Detailed Site Plan Remand Hearing Checkers Laurel

DSP-20006

SUBJECT: Detailed Site Plan DSP-20006 (Remanded)
Checkers Laurel

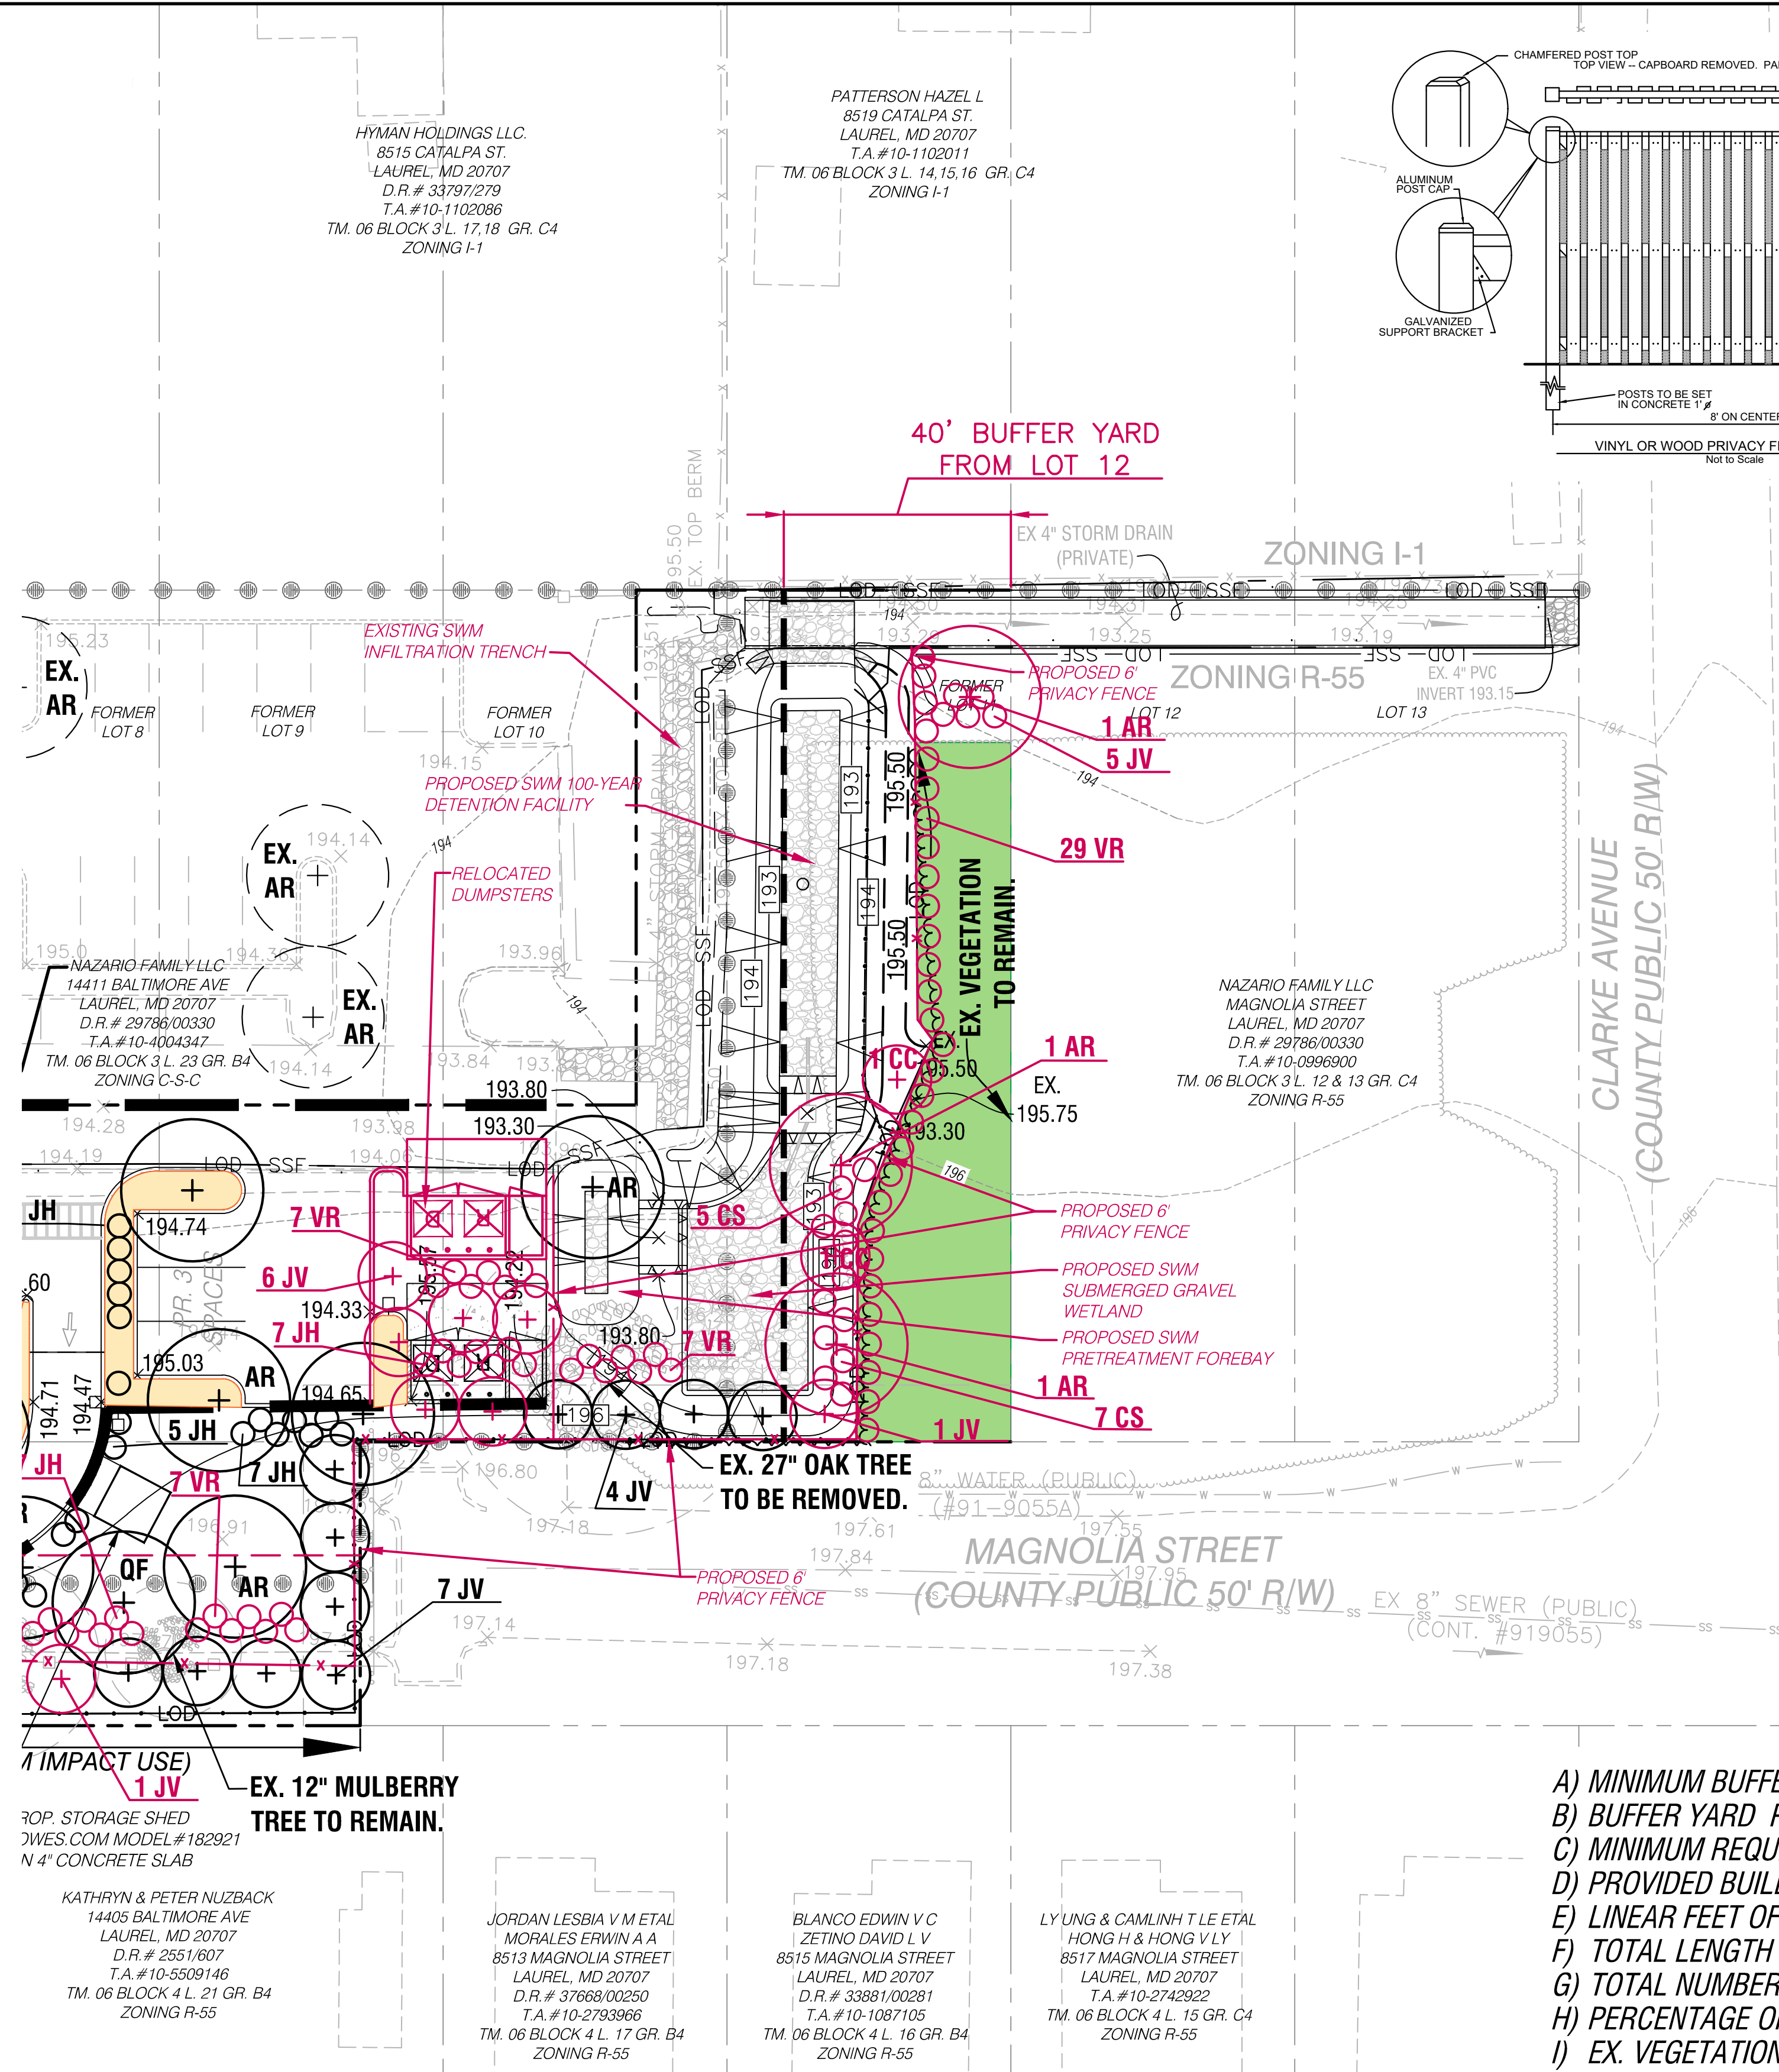
1. Prior to certification, the detailed site plan shall be revised, or additional information shall be provided, as follows:
 - f. Provide a Section 4.7, Buffering Incompatible Uses, schedule demonstrating conformance with the bufferyard required along Lot 12, or obtain approval of an alternative compliance from the requirements.
